ADDENDUM NO. 3

Project Name: Flooring and Paint Project (V2526124PWC)

Date: April 22, 2026

KEY PLAN

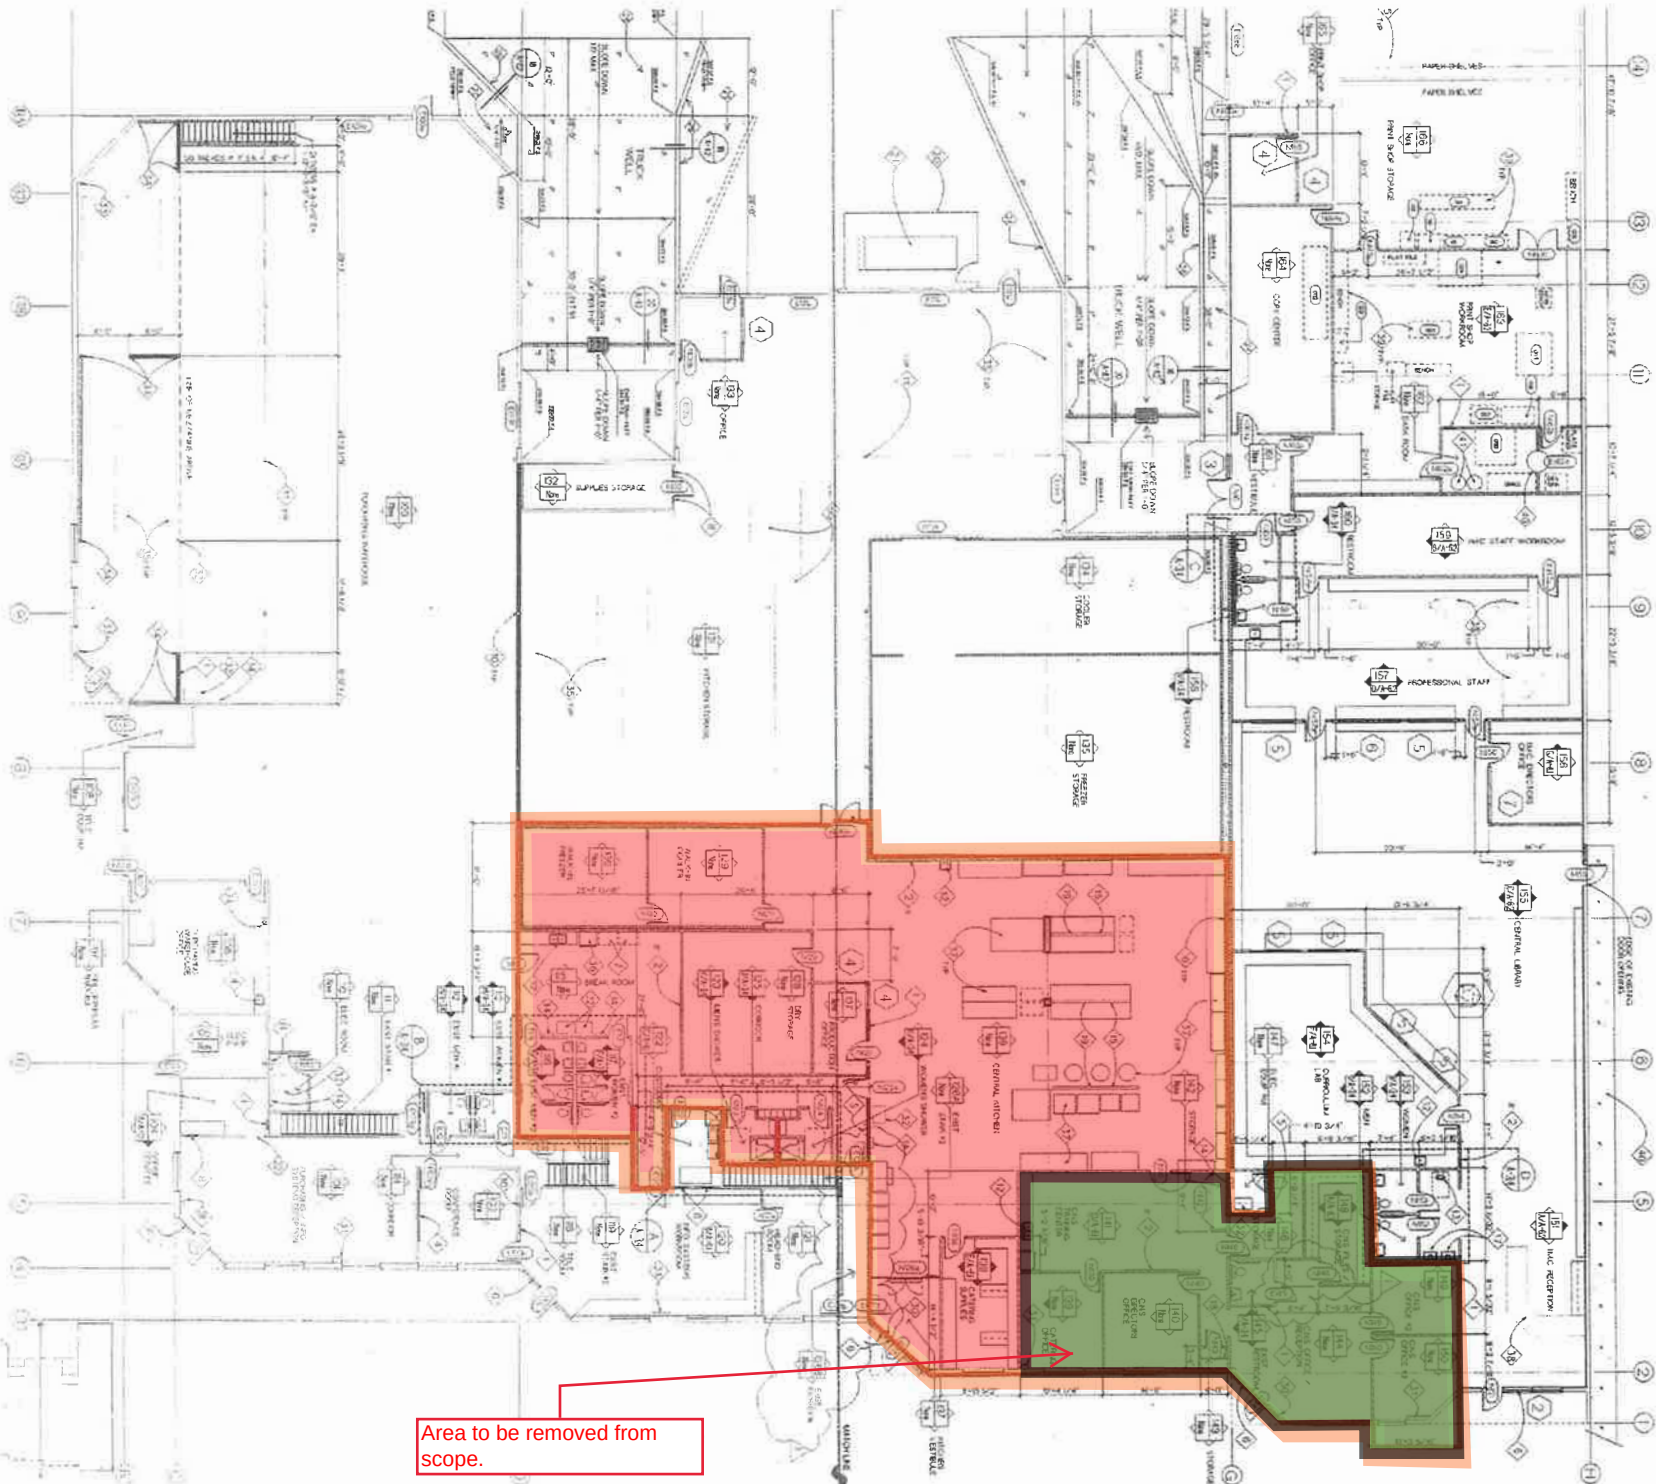
Due to scheduled conflicts with an upcoming plumbing project, the scope of work for the CNS Central Kitchen floorplan has been modified.

- Redacted Area: The area highlighted in green on the attached site map is hereby removed from the project scope in its entirety.
- Exclusions: No flooring installation, painting, preparation, or any related services are to be performed within this redacted zone.
- Bidding Requirement: Bidders must adjust their take-offs and total bid price to reflect the removal of this square footage from the project requirements.

Area to be removed from scope.
